TENNESSEE VALLEY AUTHORITY
SEQUOYAH NUCLEAR PLANT (SQN)
UNITS 1 AND 2

Relevant Sections of SQN Calculation SCG2S90088
and
ABS Consulting Report Number 116518-R-002, "Seismic Qualification
of SQN Main Control Room Suspended Ceiling and Air Delivery
Components."

Subject: Watts Bar Nuclear Plant (WBN) – License Amendment to Revise the Updated Final Safety Analysis Report and the Technical Specification Bases for the Seismic Qualification of the Main Control Room Air Delivery Components and Suspended Ceiling - Request for Additional Information.

Figure 2.2 3-D model of SQN MCR suspended ceiling. (Y axis points to the west)

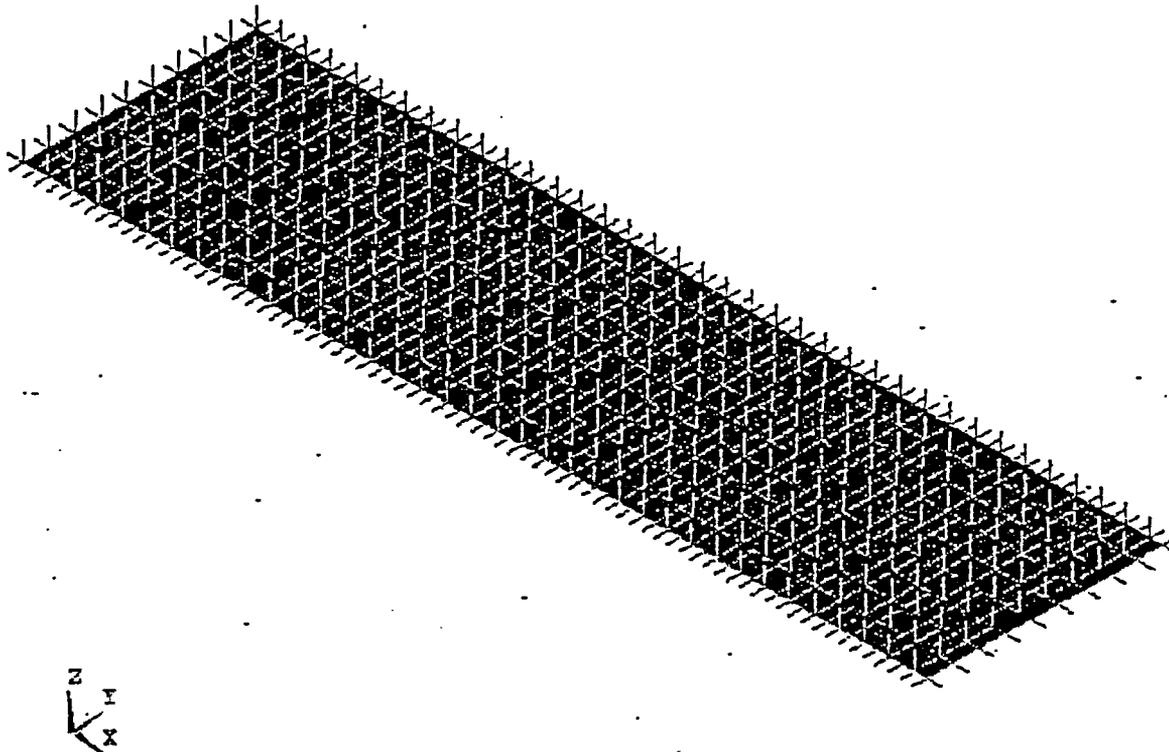
applicable to the full model shown on Figure 2-2 and how the assumptions and the limitations are properly integrated into WBN's formulation of the 3-D MCR suspended ceiling finite element model.

Figure 2.5. Rayleigh proportional damping with $\alpha = 0.2$ and $\beta = 0.001$.

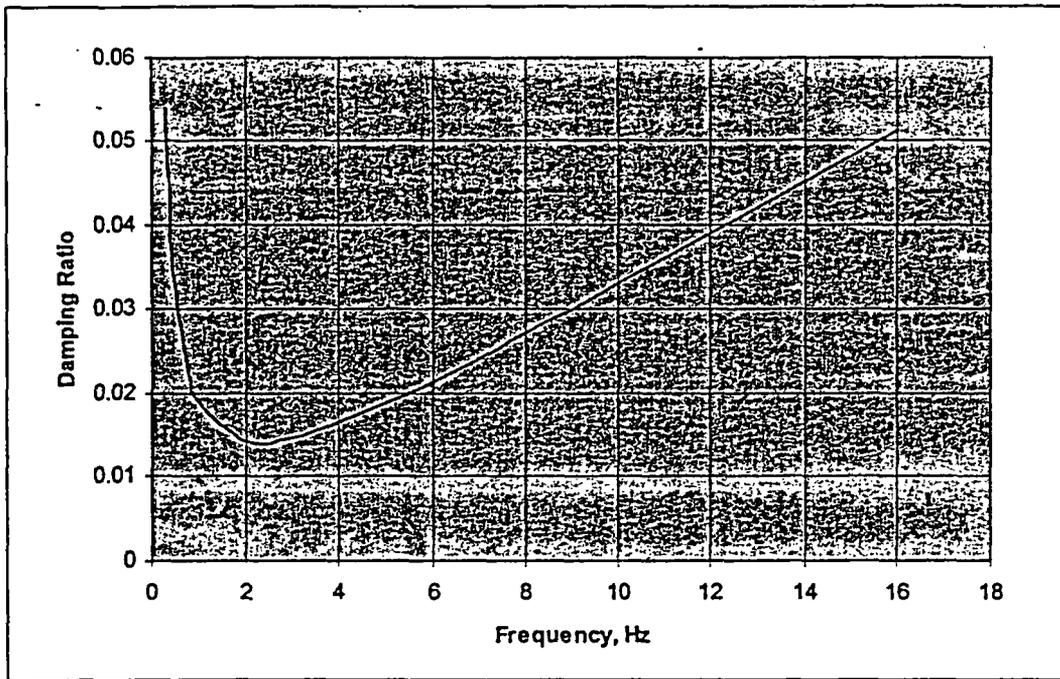
The first paragraph on Sheet 11 of Enclosure 3 states that Raleigh proportional damping with mass and stiffness proportional coefficients of 0.2 and 0.001, respectively, was used in the transient dynamic analysis. Discuss your rationale for selecting these proportional damping coefficients. Are these coefficients derived from applicable vendor model testing results or pertinent data based on past earthquake experience? Also, discuss pertinent ANSYS code verification data that support the use of the above proportional damping coefficients.

The figure on the referenced Sheet 11 of Enclosure 3 of TVA's ~~March 12, 2003~~, license amendment request illustrates this dependency of the modal damping ξ_k as a function of the modal angular frequency ω_k (for $\alpha = 0.2$ and $\beta = 0.001$).

Figure 2.5 North-south submodel. (Y axis points to the west)

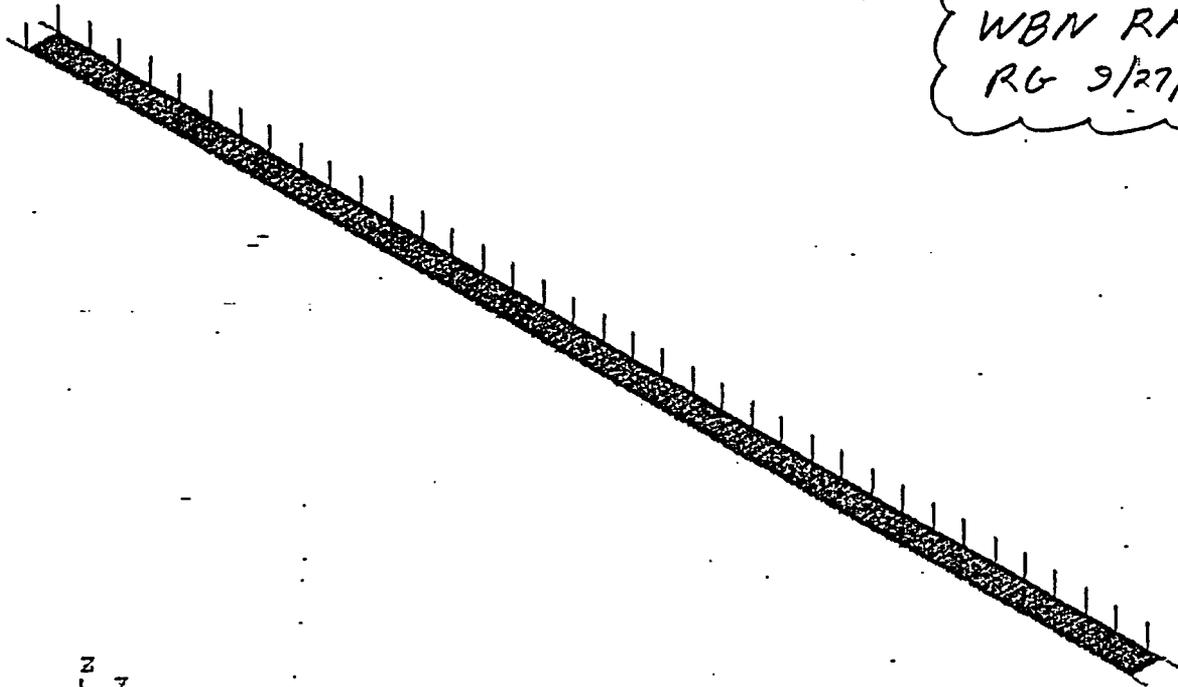
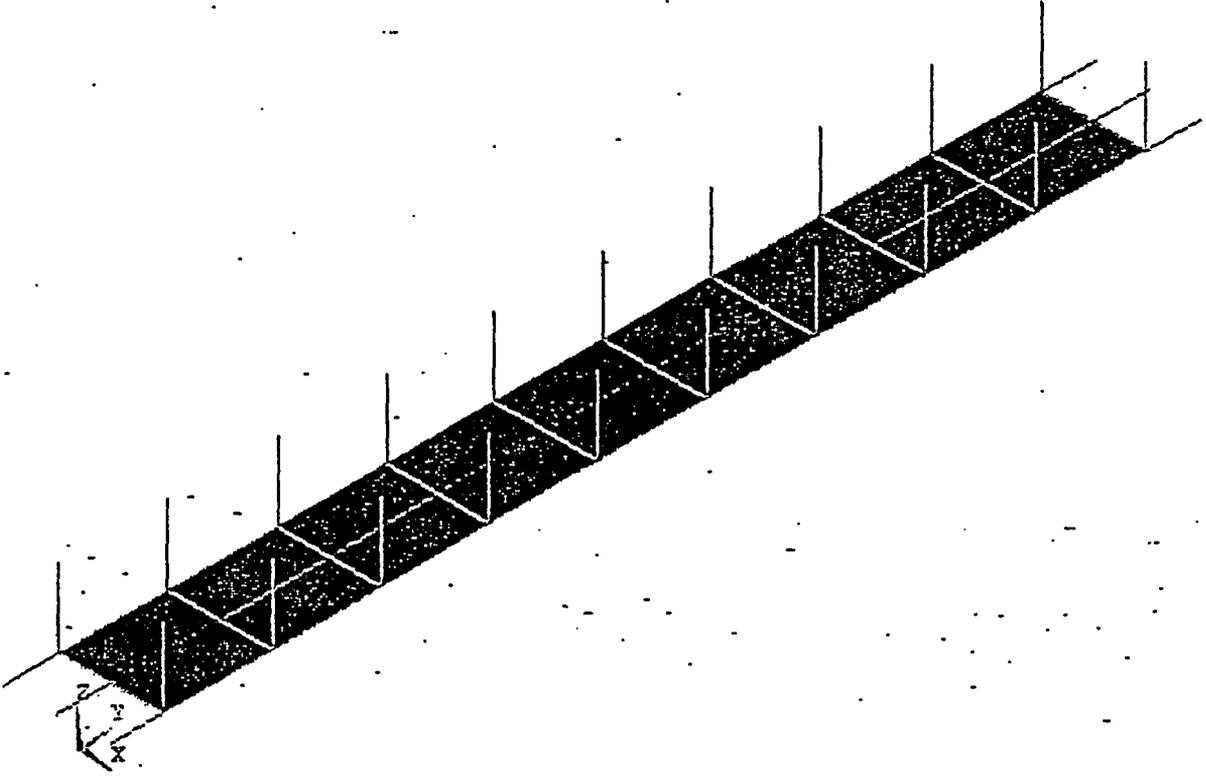
The first paragraph on Sheet 12 of Enclosure 3 states that there is very little cross coupling between the North-South and East-West responses. Discuss ~~WBN's~~ SON's quantitative basis for asserting that only minimal cross coupling effects exist for the Main Control Room ceiling system. Also, indicate how your sub-modeling approach in the proposed analysis affect the results when compared with a rigorous 3-D seismic response analysis. Discuss ~~WBN's~~ SON's specific method used to combine the seismic responses due to each of the three component earthquake time history motions.

Both the North-South and East-West strip models are subjected to the same vertical time history input. Examination of the results on Page 1817 of Report 1116518-R-0012 indicates that the calculated minimum wire forces for the North-South and East-West strip models are nearly the same, indicating that the vertical response is dominated by vertical input and that there is very little cross-coupling between North-South or East-West, as expected.

SHEET NO. A-4

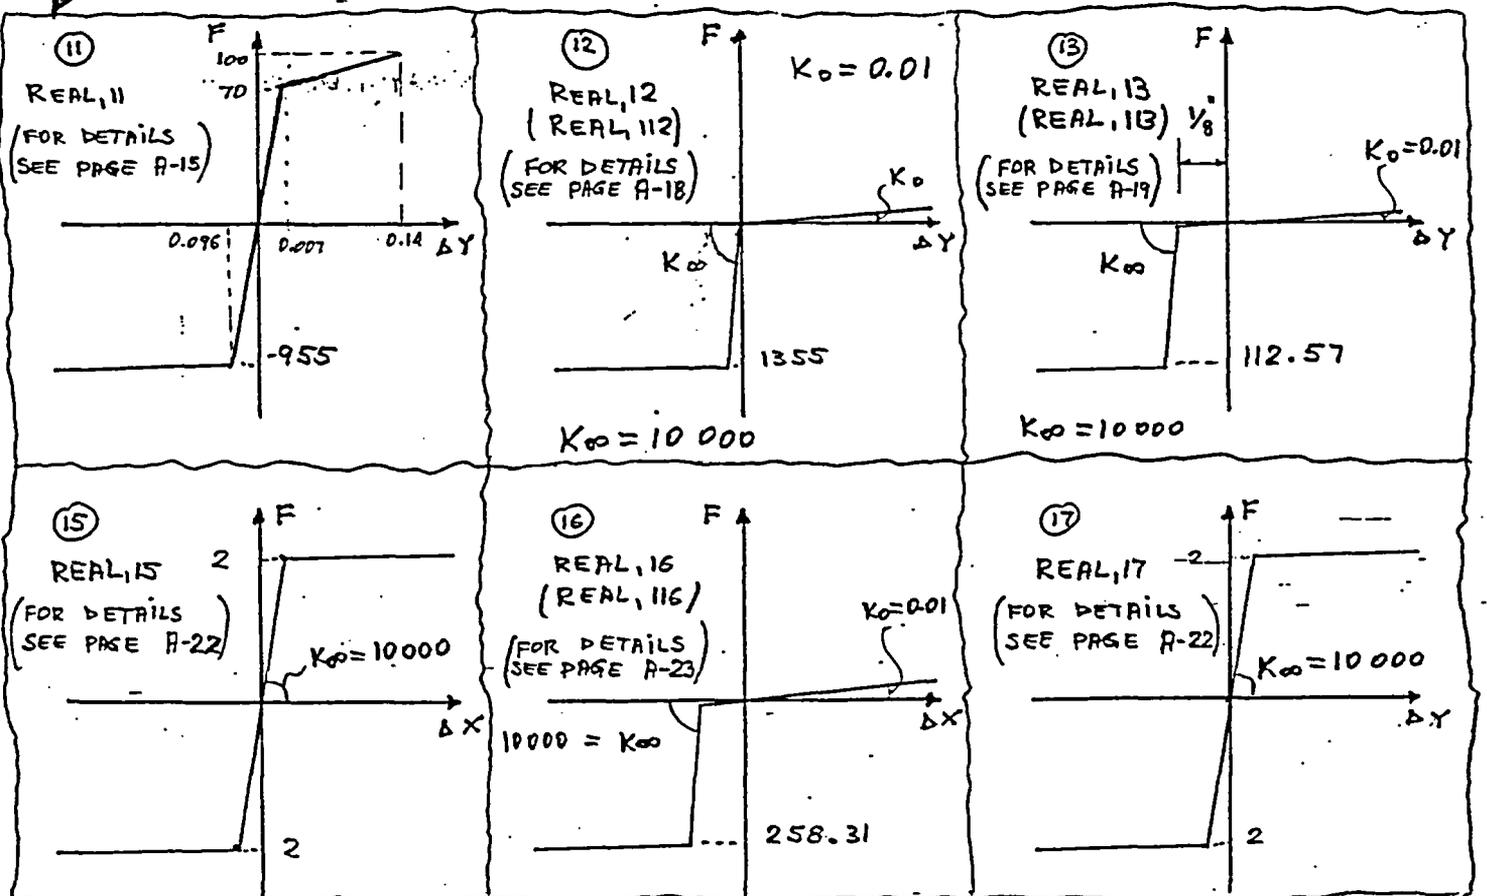
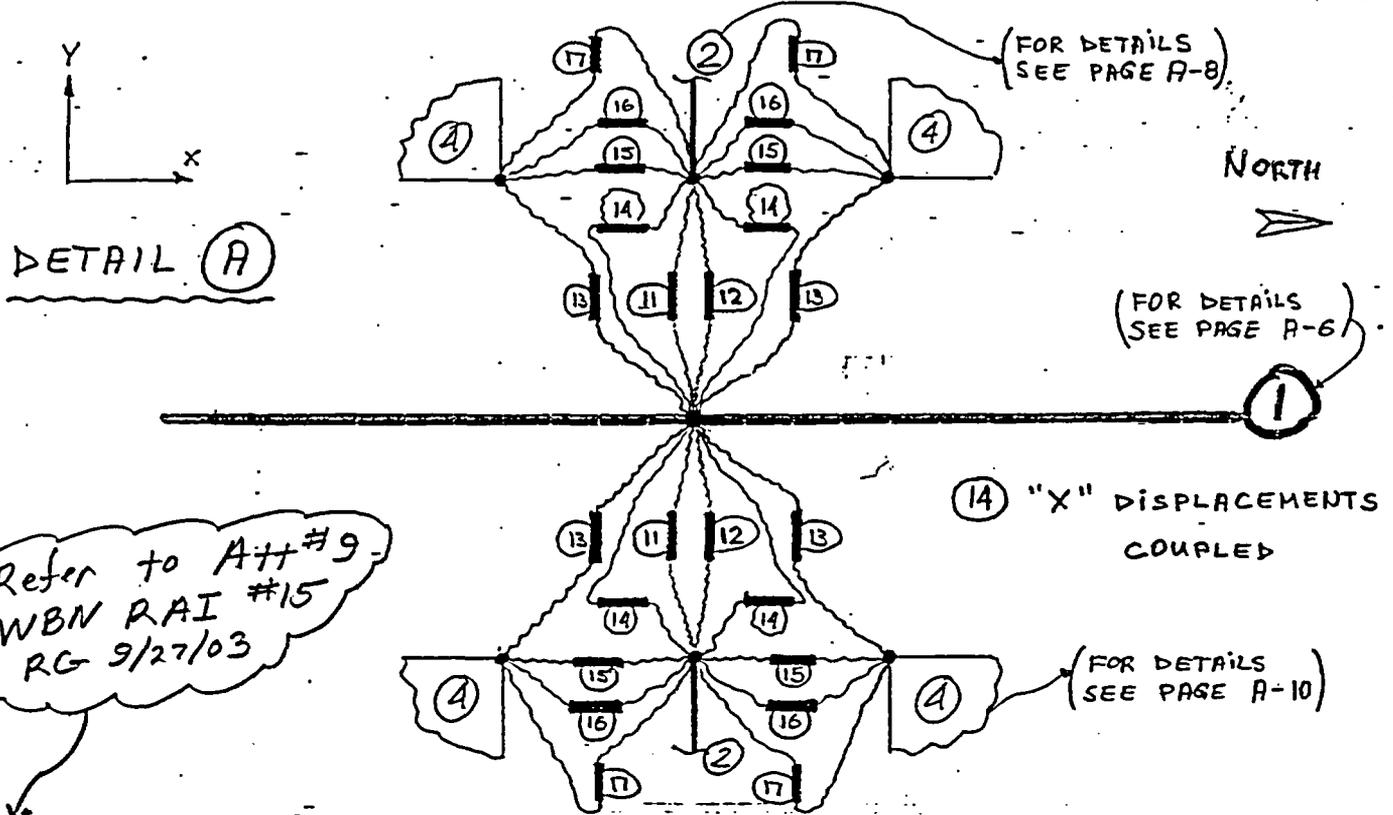
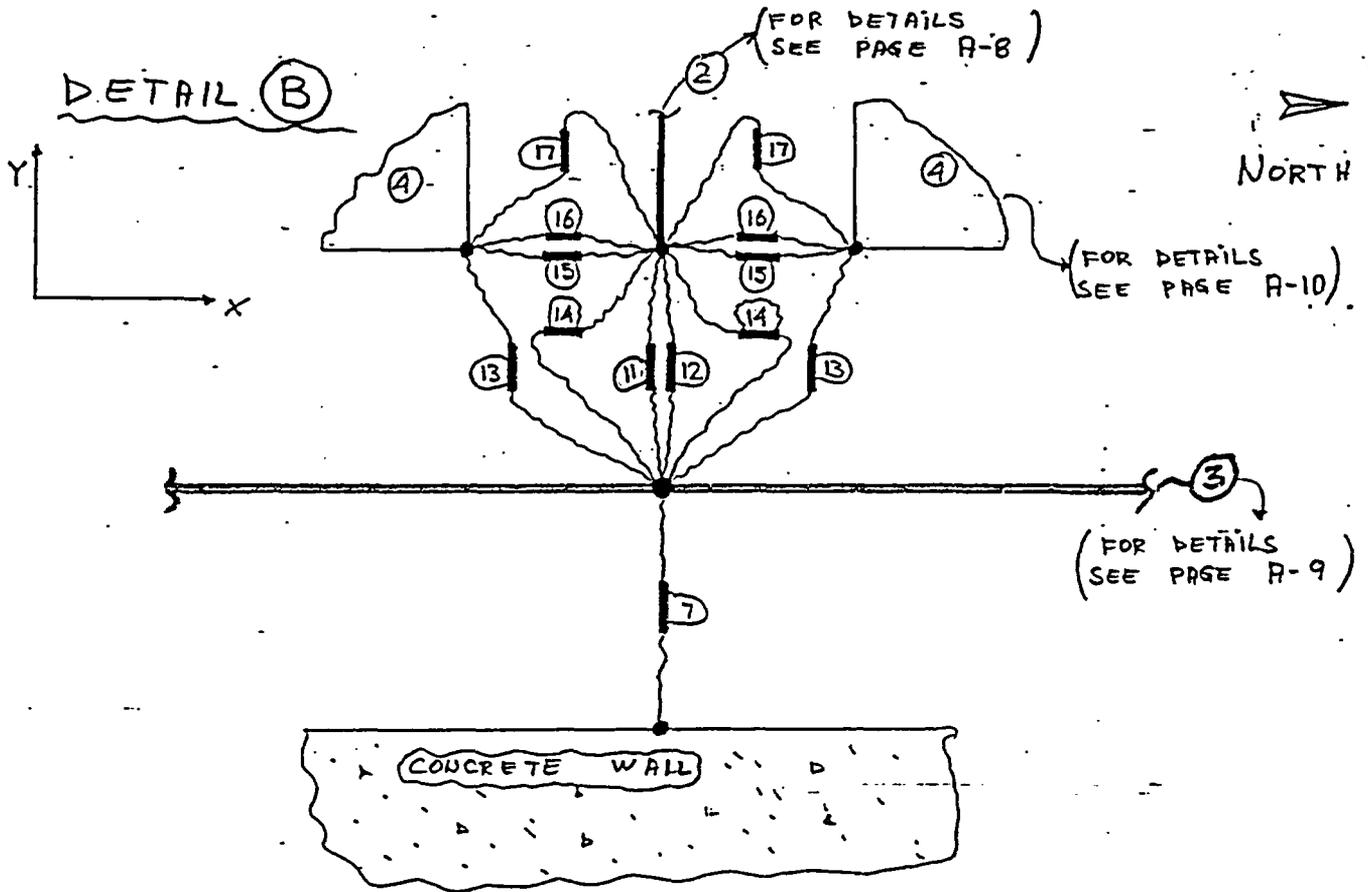
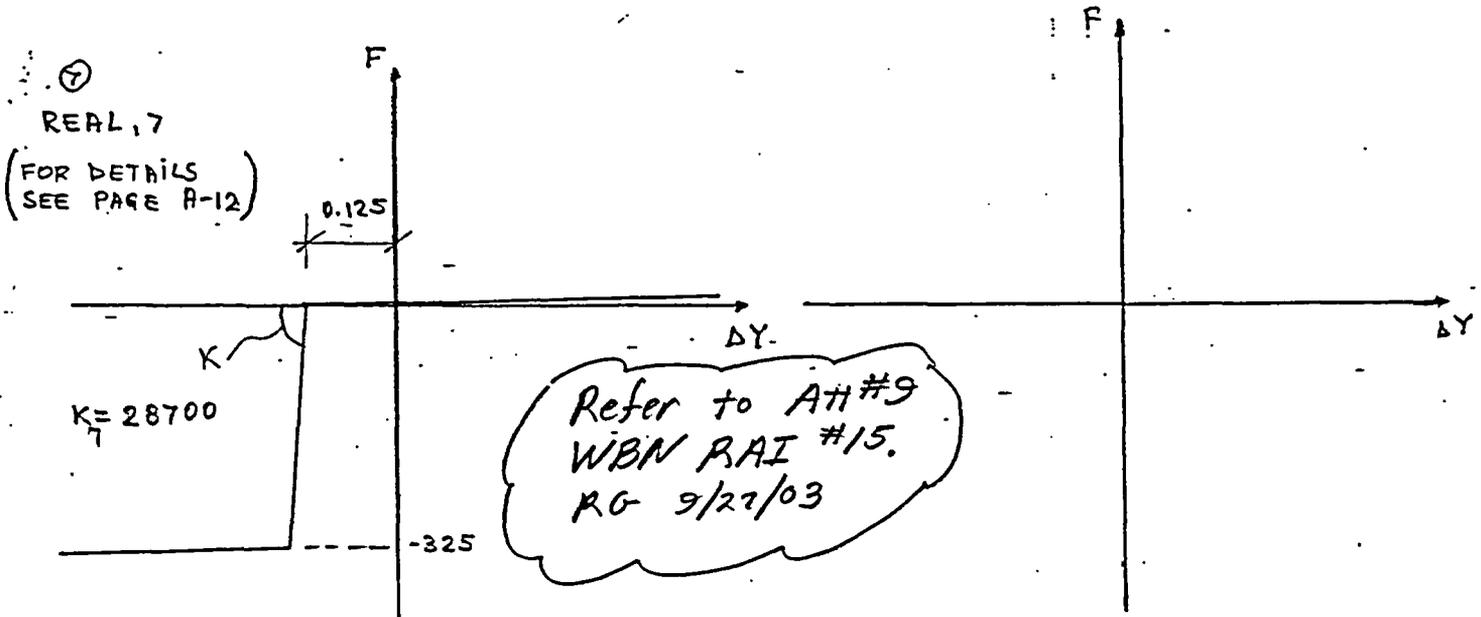
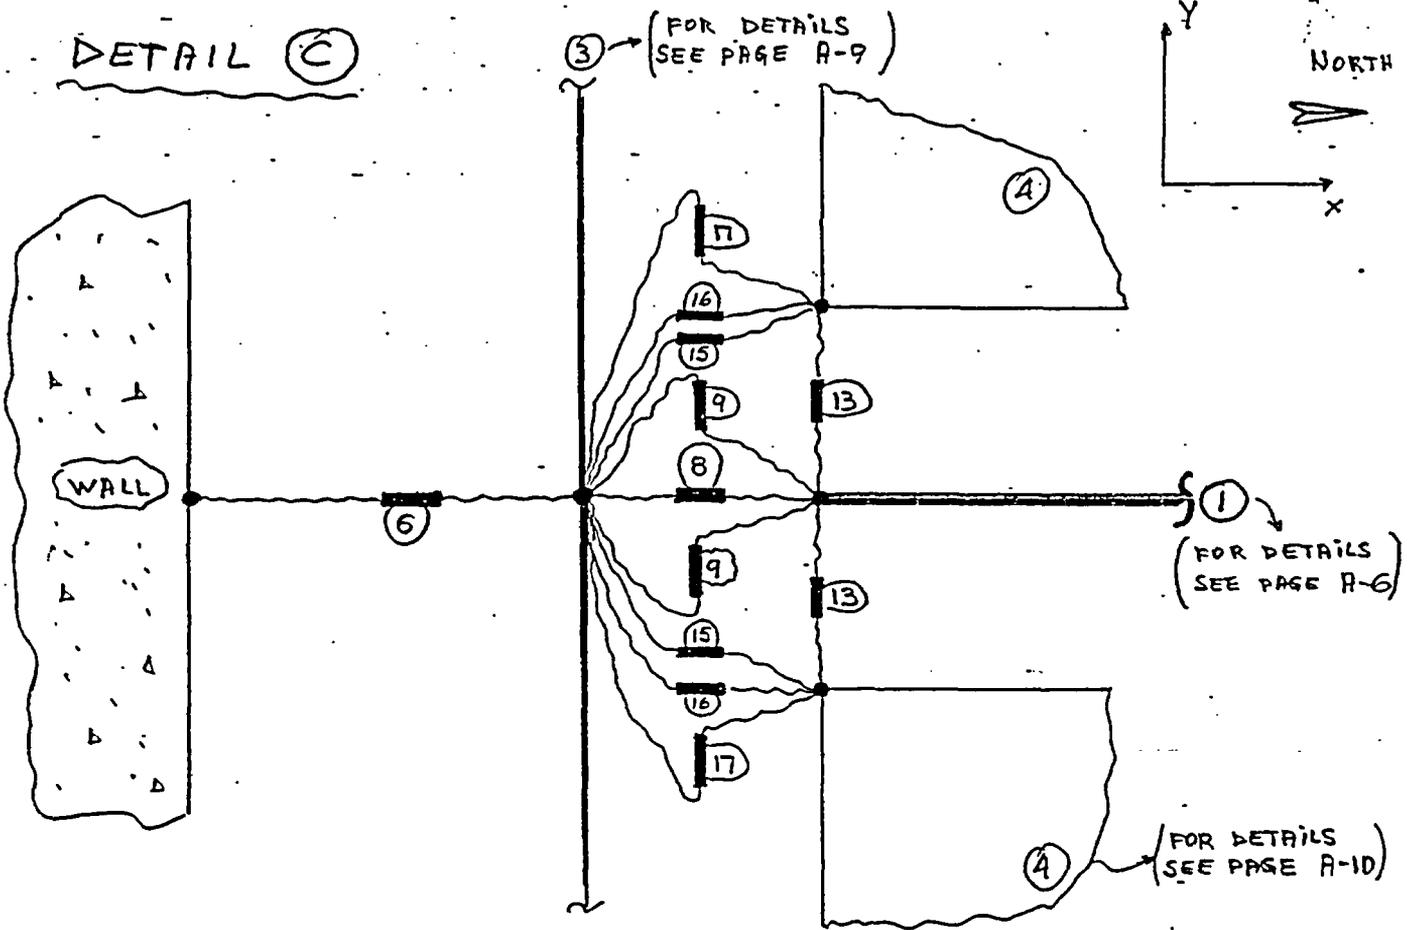
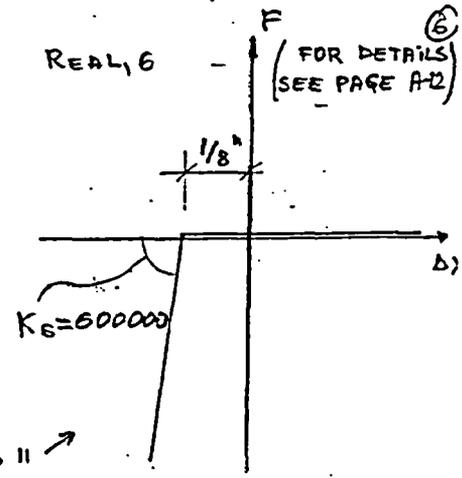
Referring to the various stress-strain curves presented on Sheets A-3 through A-5 of Appendix A, provide a discussion of the basis, including available material test data, for your quantitative definitions of various deformable/flexible elements representing the transient finite element dynamic analysis model. Also discuss both upper and lower bound results of the key grid member responses under the ~~WBN~~ SON SSE and the sensitivities of the members' seismic response with respect to the quantitative parameters selected for the stress-strain curves representing various model elements.
